# Commonwealth Edison Company

SUBJECT: LICENSE DPR-19, DRESDEN NUCLEAR POWER STATION - UNIT #2

## DESIGN MODIFICATION

FIG. 1

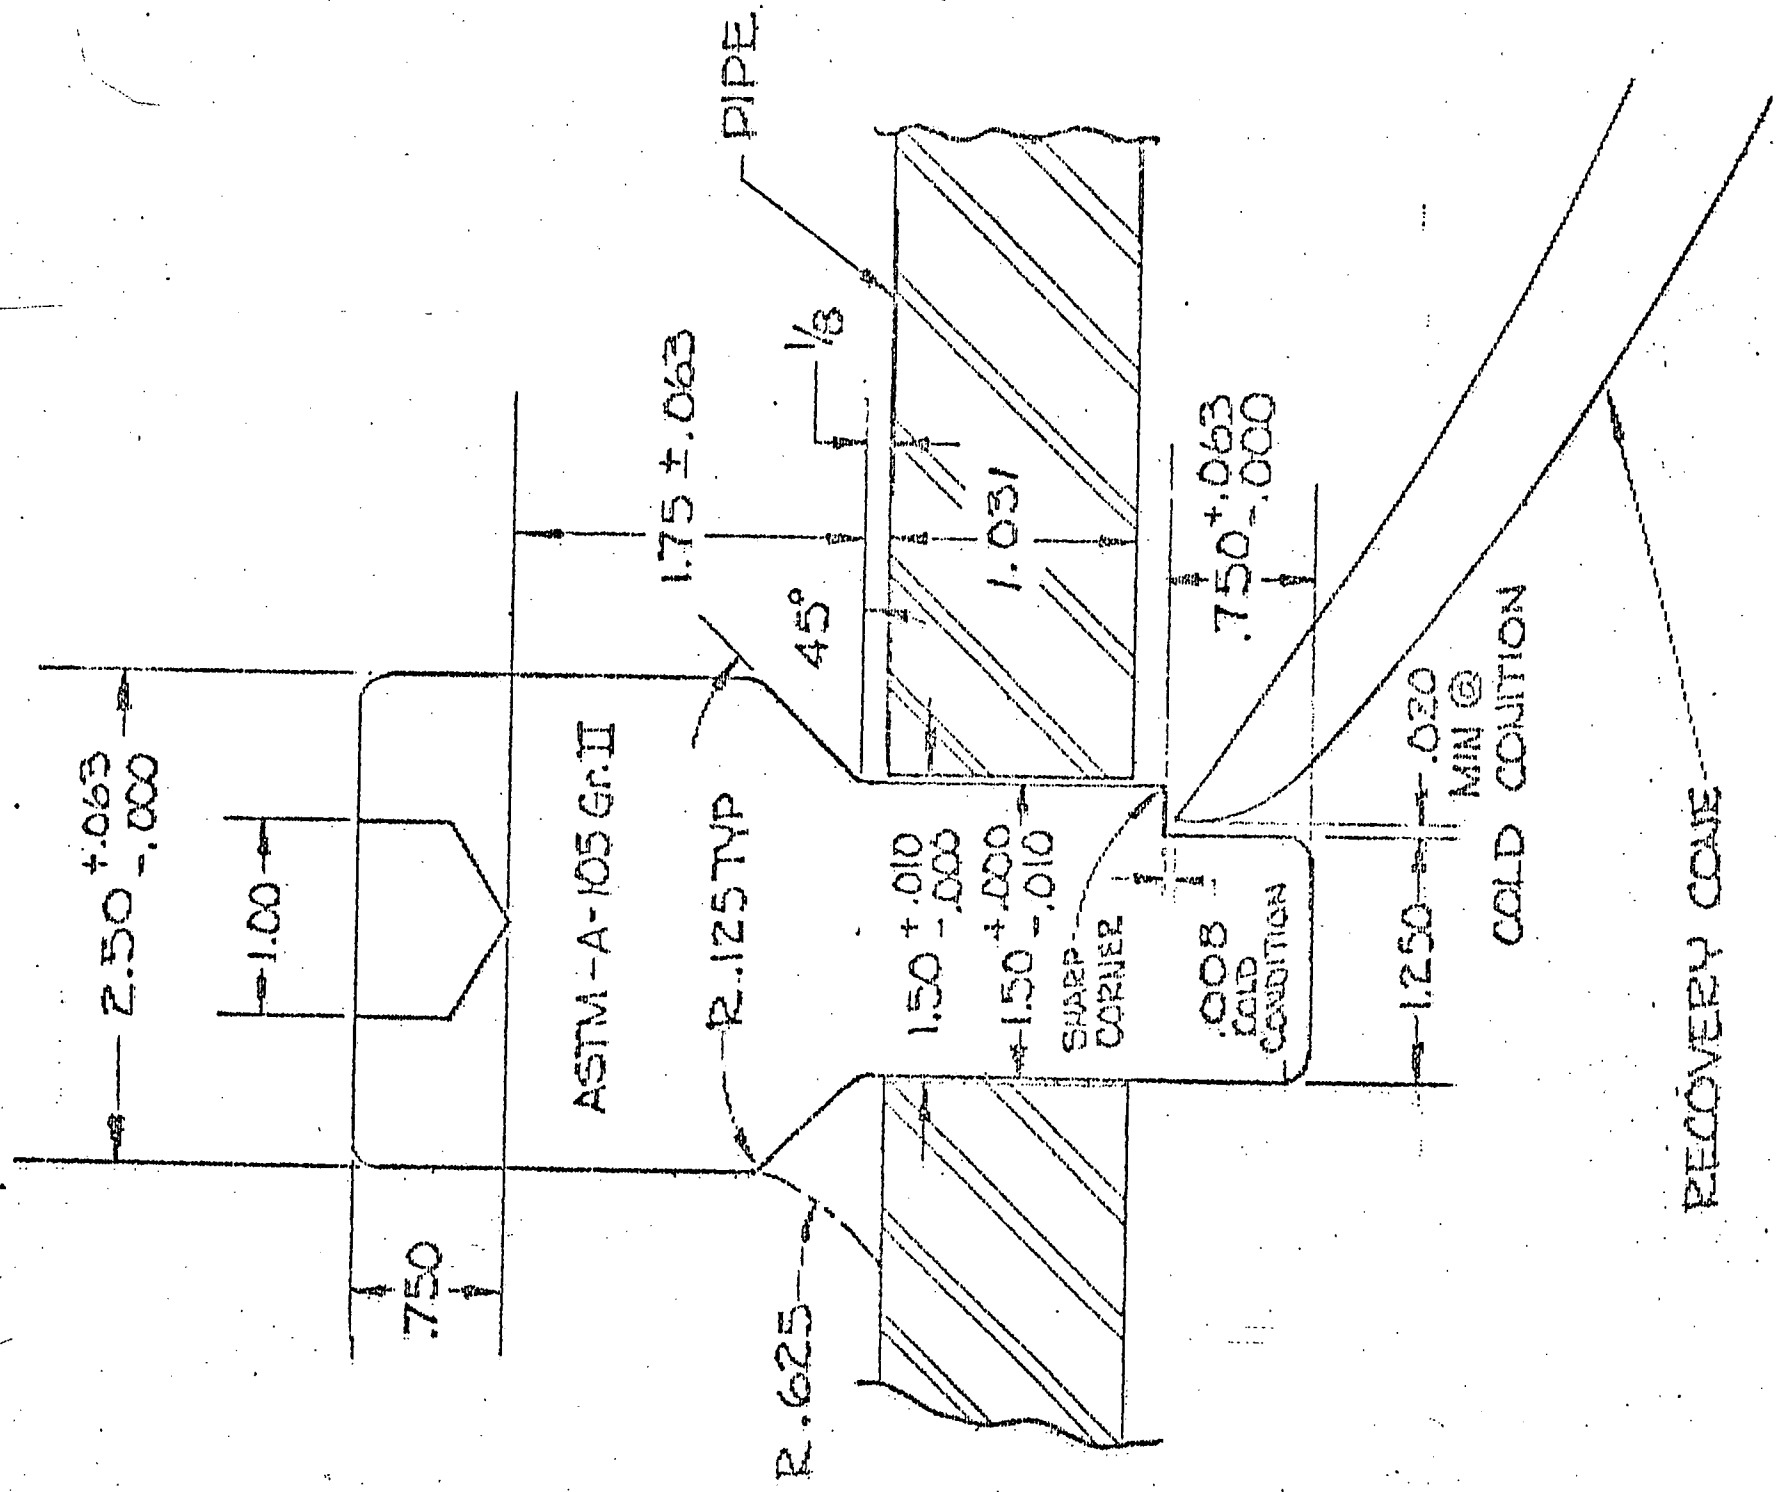
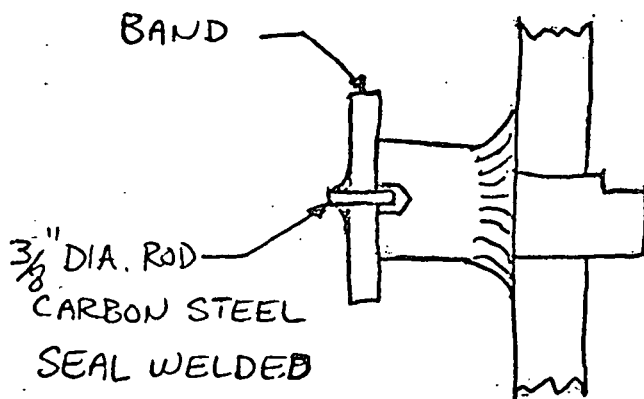
1. The Dresden II main steam flow element is modified by installing three (3) pins at 120° apart downstream of the recovery cone, with a clearance of .020" minimum to take care of the differential thermal expansion between pipe (carbon steel) and flow element cone (stainless steel) as shown on Figure 1, attached. Based on the assumption that the throat-to-recovery-cone weld on the A, C & D lines fail, these pins are designed to prevent the recovery cones from moving down stream into the MSIV. These pins will also prevent any vibration of the downstream recovery cone that may exist during operation. Stress analyses show that if the downstream cone should fail and be held by only one pin, the pin shear stress will be 13,866 psi if 100 psid exists across the restrictor. This assumption is very conservative because normal operating differential is approximately half of this. The allowable stress for this emergency condition is 90% of yield strength, or 27,800 psi (Note:  $S_m = 18,600$ ). Since the maximum stress with only one pin carrying the load is 13,866 psi, the design of the pins is more than adequate.

Area replacement was also considered in designing these pins, based on ASME-Section III, 1971, Paragraph NE-3643.3 - Reinforcement for Openings.

$$\text{Area removed} = 1.389 \text{ in}^2 \quad / \quad \text{Area Available} = 1.688 \text{ in}^2$$

Combined stress in 1½" pin weld is 9,259 psi. Includes pressure and temperature stress plus the stress due the cone resting on one pin. Allowable stress is 18,600 psi.

FIG 1A

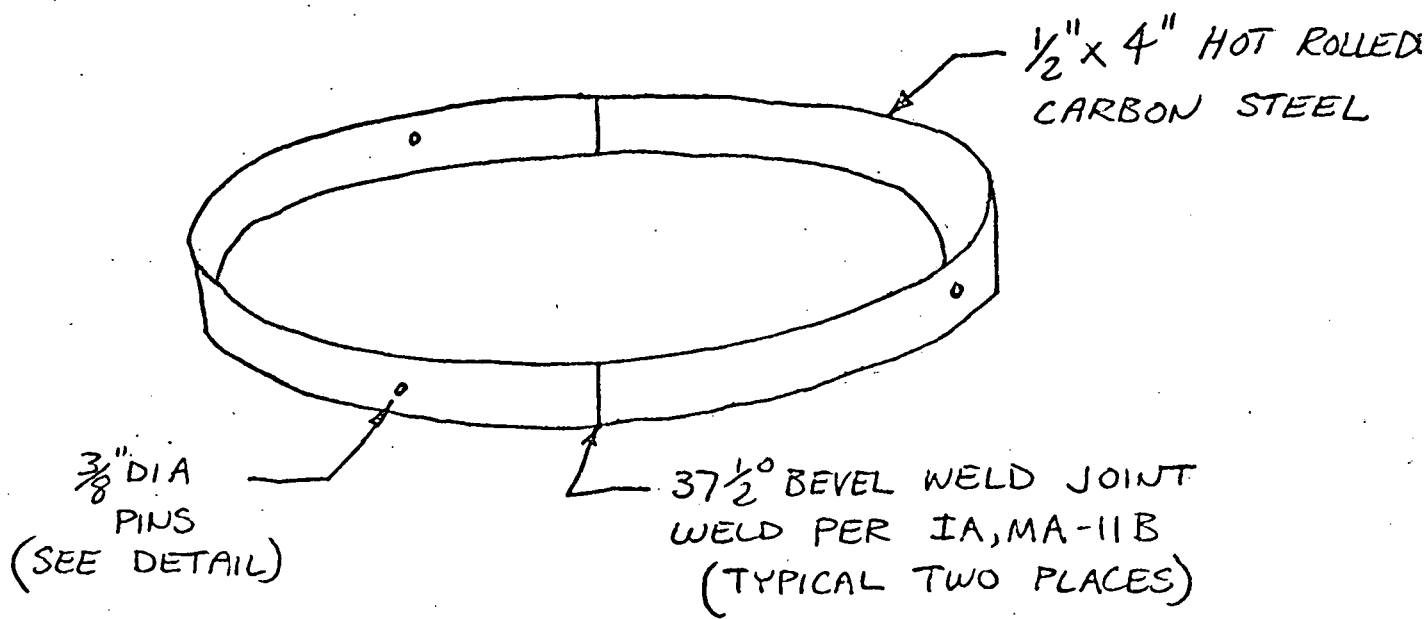
A retaining clamp, or "belly band", has been installed around these pins as indicated on Figure 1A attached. Because the pins are not threaded into the pipe, this was added to prevent expulsion of the pins in the unlikely event that the welds were to fail.
